[Docket No. FAA-2020-0883; Project Identifier 2019-CE-034-AD; Amendment 39-21460; AD 2021-05-17]

Airworthiness Directives; Rockwell Collins, Inc. Flight Display System Application

ACTION: Final rule.

Figure 1 to paragraph (g)(1)(iii); placard location on bezel

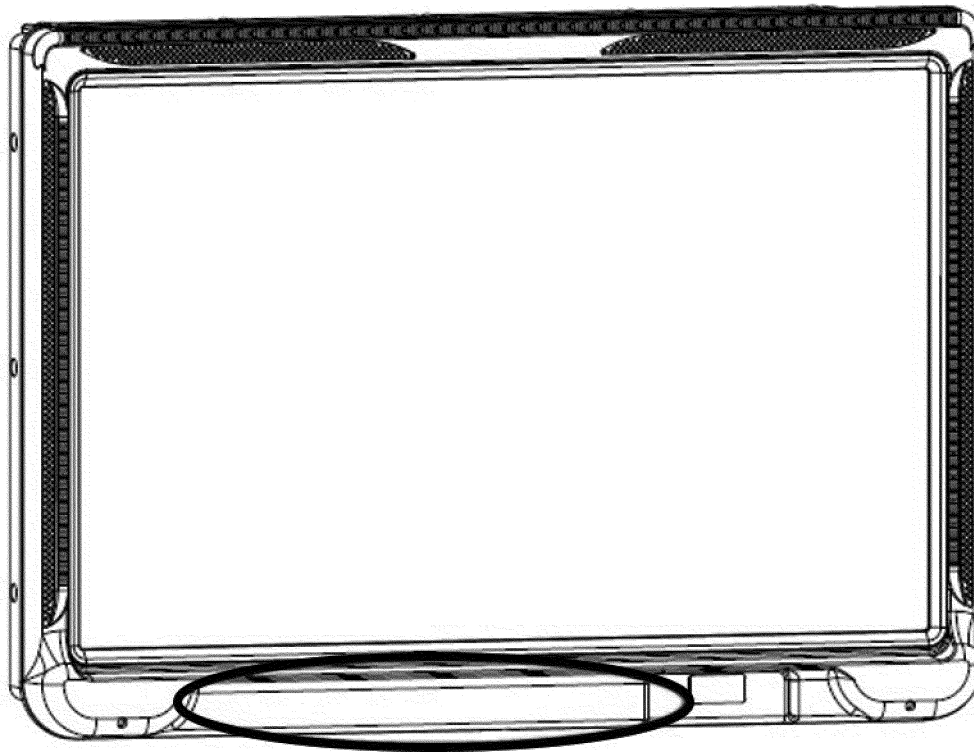
(ii) Fabricate a placard for each aircraft primary flight display, using at least 1/8 inch letters, with the following text: TCAS Flight Ops—TA Only mode (TA/RA mode prohibited).

(iii) Install the placard on the bottom of each aircraft primary flight display bezel in the area depicted in figure 1 to paragraph (g)(1)(iii) of this AD.
